SIR FREDERICK MESSER ESTATE

NMA SECTION 96 APPLICATION

REVISION: P06

DATE: June 2026

SECTION 2 Block 02_Typical Floor Plan

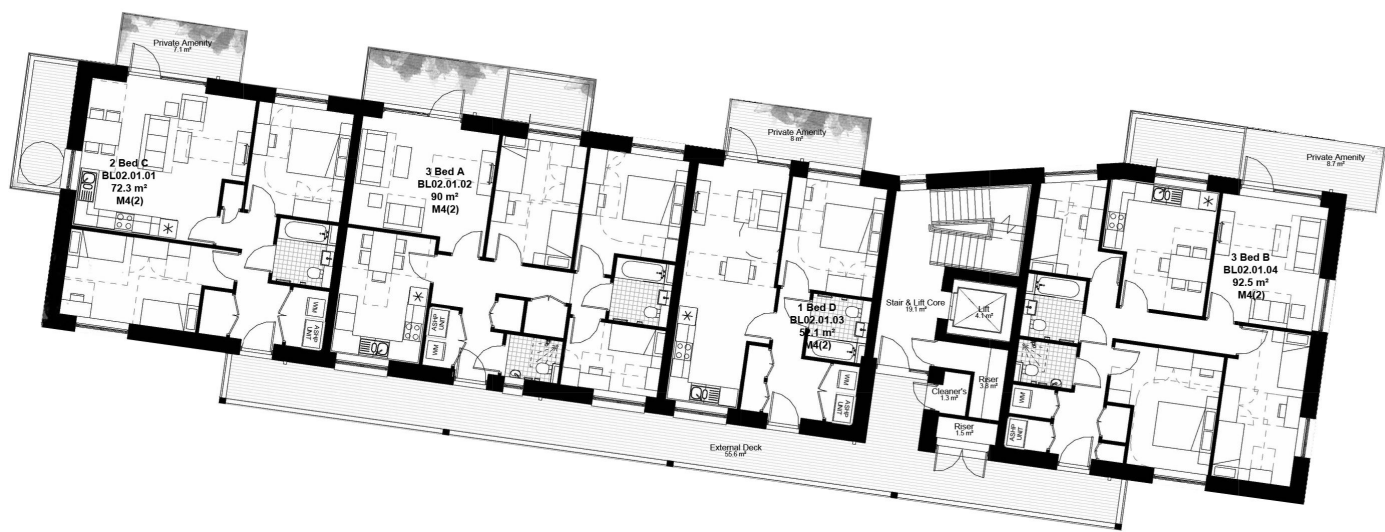
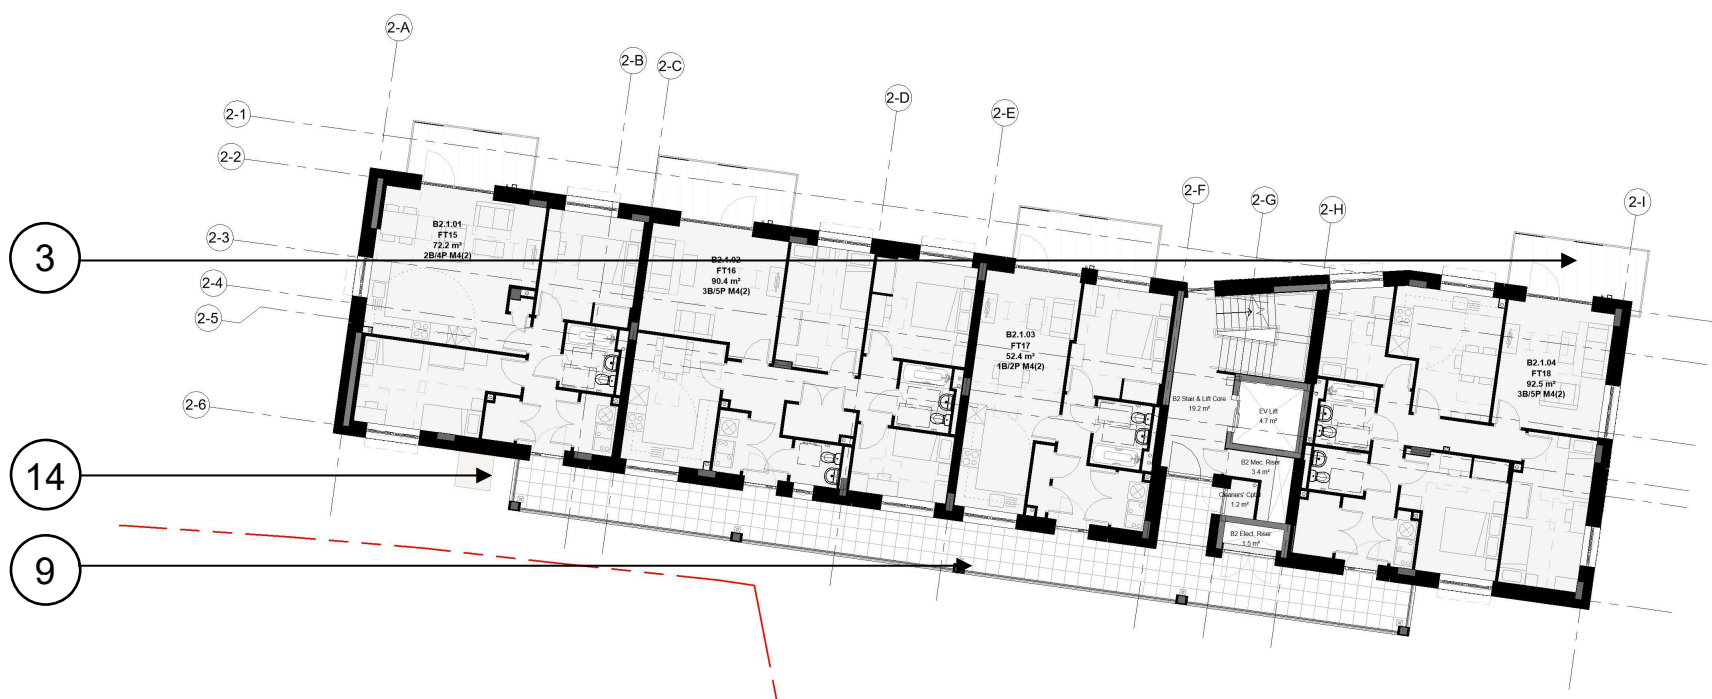
3. Corner bolt-on balconies cantilevered reduction.

9. Aluminium metal cladding to external columns at inset balcony corner and external walkways in upper levels.

14. Canopy over entrance door added.
